DART AEROSPACE LTD	Work Order: 99237
Description: Crosstube Assembly (205/212 High Aft)	Part Number: D212-664-241
Inspection Dwg: D212-664-241 Rev: D	Page 1 of 2

DESIGN	PH	DART AEROSPACE LTD	
DRAWN	RF	HAWKESBURY, ONTARIO, CANADA	
CHECKED	JP	DRAWING NO.	REV. D
MFG. APPR.	JS	D212-664-241	SHEET 2 OF 4
APPROVED	JP	TITLE	SCALE
DE APPR.	JP	CROSSTUBE ASSY (205/212 HI AFT)	NTS
DATE	09.09.30	<small>COPYRIGHT © 2006 BY DART AEROSPACE LTD THIS DOCUMENT IS PRIVATE AND CONFIDENTIAL AND IS SUPPLIED ON THE EXPRESS CONDITION THAT IT IS NOT TO BE USED FOR ANY PURPOSE OR COPIED OR COMMUNICATED TO ANY OTHER PERSON WITHOUT WRITTEN PERMISSION FROM DART AEROSPACE LTD.</small>

DRAWING NO. D212-664-241	TITLE CROSSTUBE ASSY (205/212 HI AFT)	REV. D	DART AEROSPACE LTD ENGINEERING ORDER		D.E.O. NO. D212-664-241-D-1	SHEET NO. SHEET 1 OF 2	SCALE NTS
DRAWN	CHECKED	MFG. APPR.	APPROVED	DE APPR.			
DATE 11.04.07	DATE 11.04.11	DATE 11.04.12	DATE 11/04/12	DATE 11.04.12

DRAWING NO. D212-664-241	TITLE CROSSTUBE ASS'Y (205/212 HI AFT)	REV. D	DART AEROSPACE LTD ENGINEERING ORDER		D.E.O. NO. D212-664-241-D-2	SHEET NO. SHEET 1 OF 1	SCALE NTS
DRAWN 90	CHECKED ASS	MFG. APPR. [Signature]	APPROVED [Signature]	DE APPR. [Sign

**D212-664-241/-241B
ASSEMBLY DETAIL**

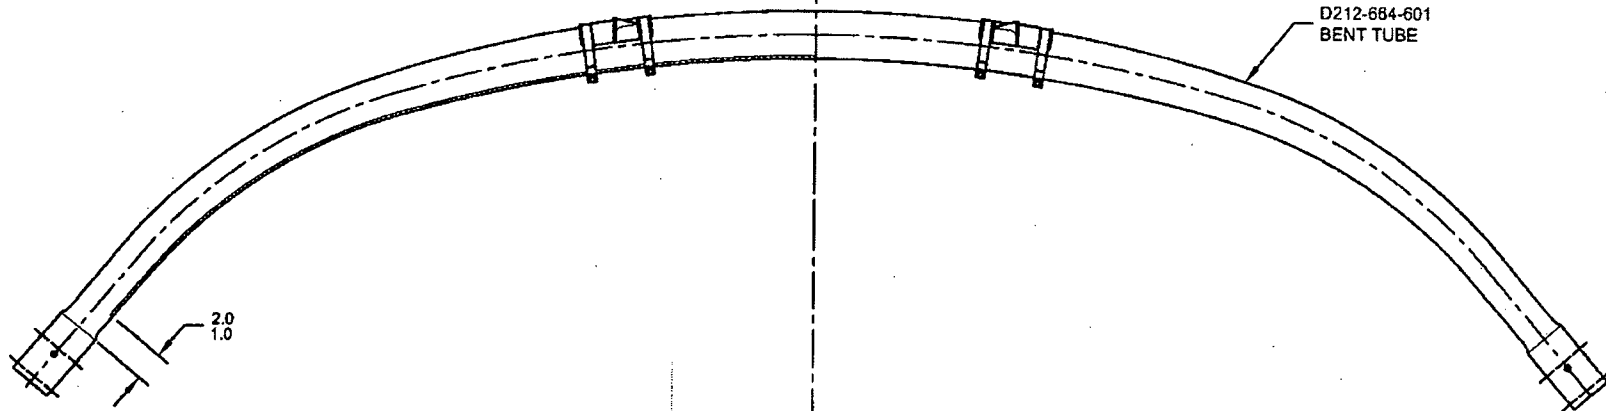
PURPOSE:

ADD AN INSPECTION WINDOW TO UNDERSIDE OF CROSSTUBE.

IS:

WAS:

MASK AREA PRIOR TO PAINTING,
REMOVE MASKING AFTER PAINT
AND APPLY CLEAR COAT
